## Product Change Notice (PCN)

**Subject:** Assembly factory and front-end process change for Shunt Regulator IC (SOP-8)

**Publication Date:** 3/11/2024

<Material>

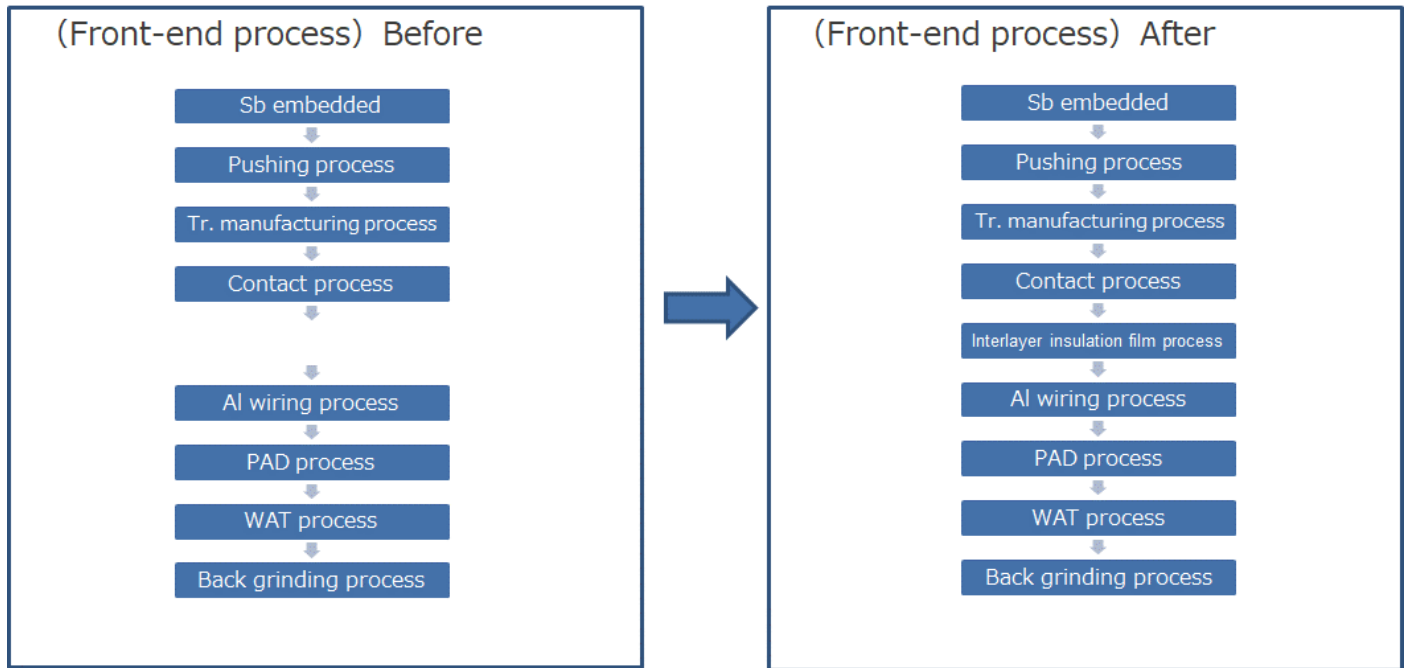
Some materials are different, but these materials have been mass-produced.

Material	Before the change	After the change
Lead flame	Fe-based	Cu-based (Palladium Pre-Plated Lead Frame)
Resin	Epoxy resin	Epoxy resin (Halogen free)
Planting	Sn-Bi	Pd (Palladium Pre-Plated Lead Frame)
Wire	Au(23um)	Au(25um)

<Form>

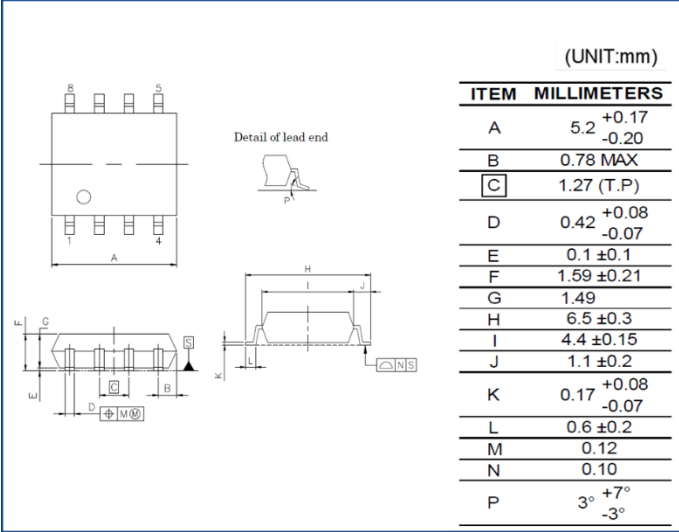
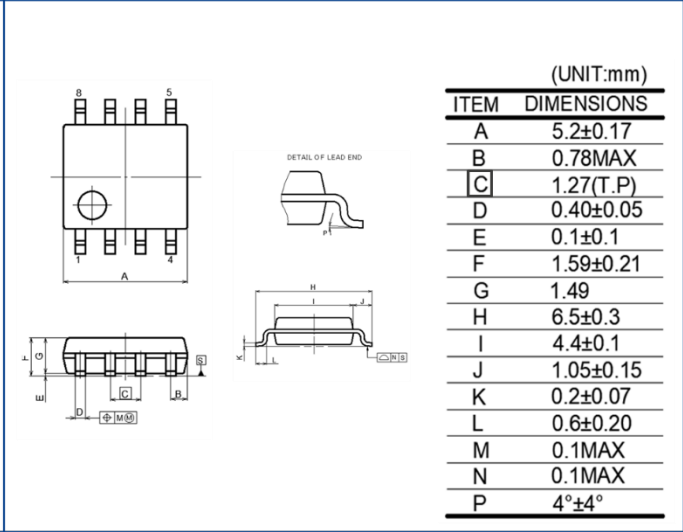
There are some differences in dimensions in the outline drawing, but the recommended foot pattern is not change.

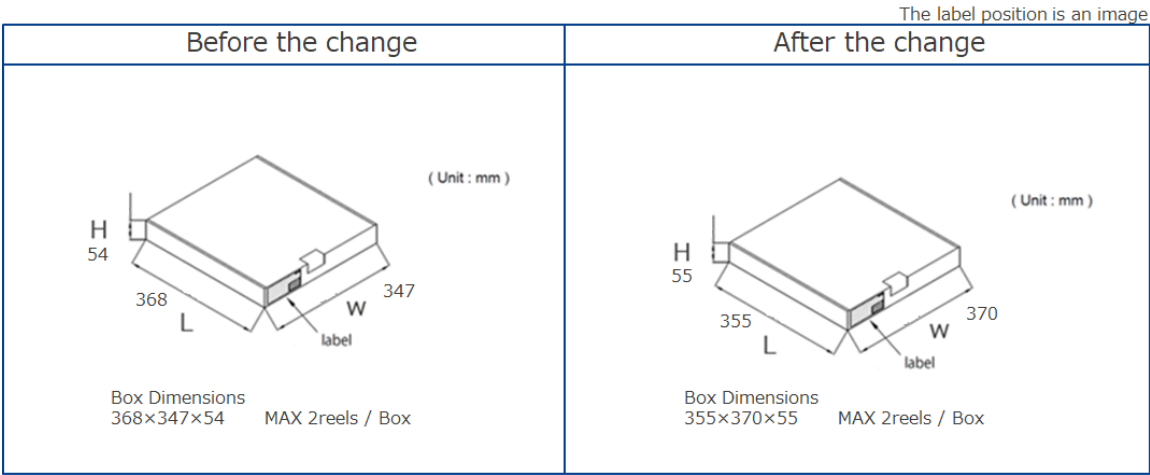
The size of the tape product packaging box changes as shown below.  
This is the standard specification that have a proven track record in mass production.

Before (L×W×H)	After (L×W×H)
368×347×54 (mm)	355×370×55 (mm)

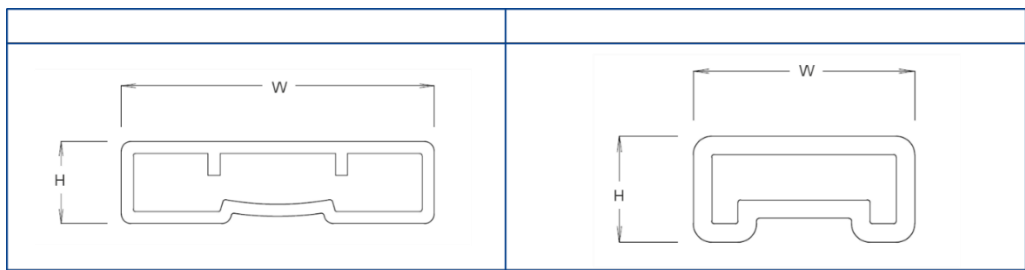
The size of the tube changes as shown below.  
This is the open products that have a proven track record in mass production.

Before(L×W×H), Number of packages	After(L×W×H) , Number of packages
530×13×3.4 (mm),Max100 pcs	507~509×8.4×4.0 (mm) ,Max90 pcs

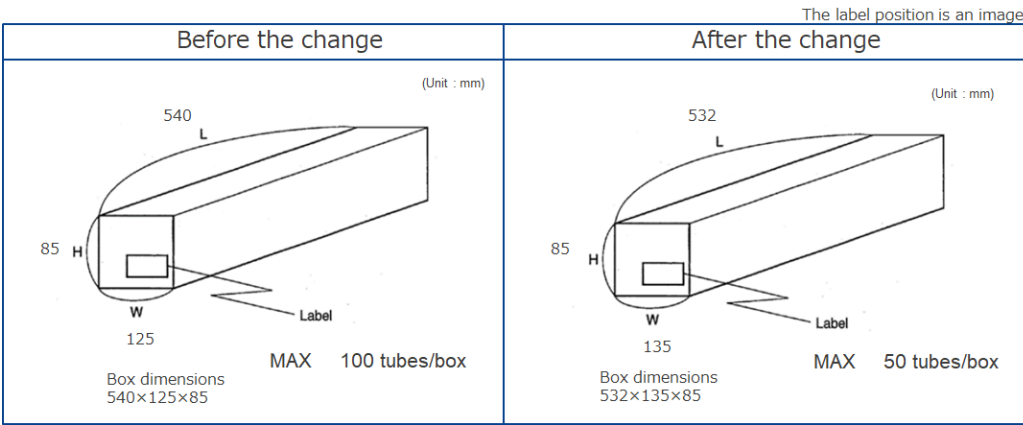
The size of the tube product packaging box changes as shown below.  
 This is the standard specifications that have a proven track record in mass production

Before (L×W×H)	After (L×W×H)
540×125×85 (mm)	532×135×85 (mm)

Product identification

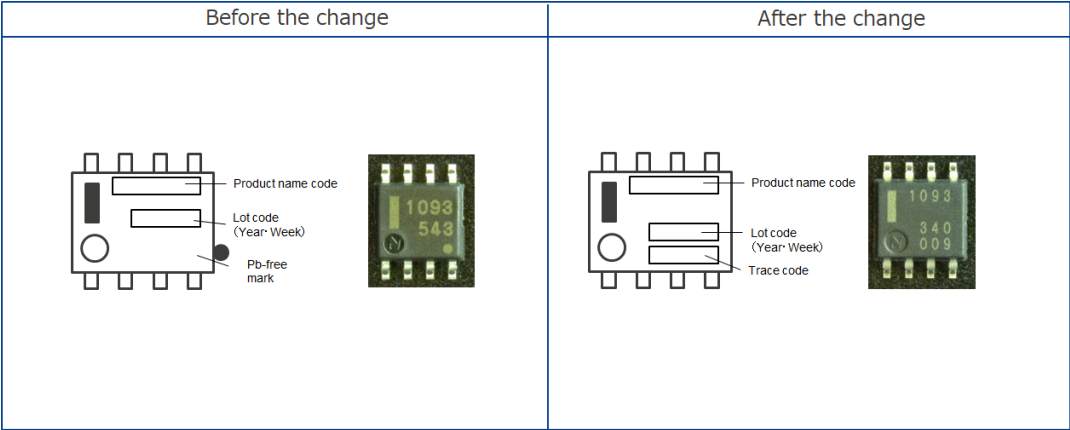
The appearance (Font, Delete Pb-free mark, Add the trace code) of the Mark/ Package Outline of products is different, but Product name code/ Lot code of Mark/Package Outline information is the same.

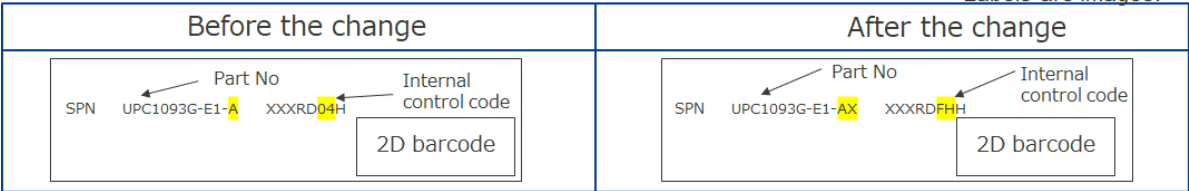
Production sites can be identified by the Labels (Reels, interior boxes).

Item	Before		After
End number of Part No	: -A	→	-AX
Internal control code	: 04	→	FH
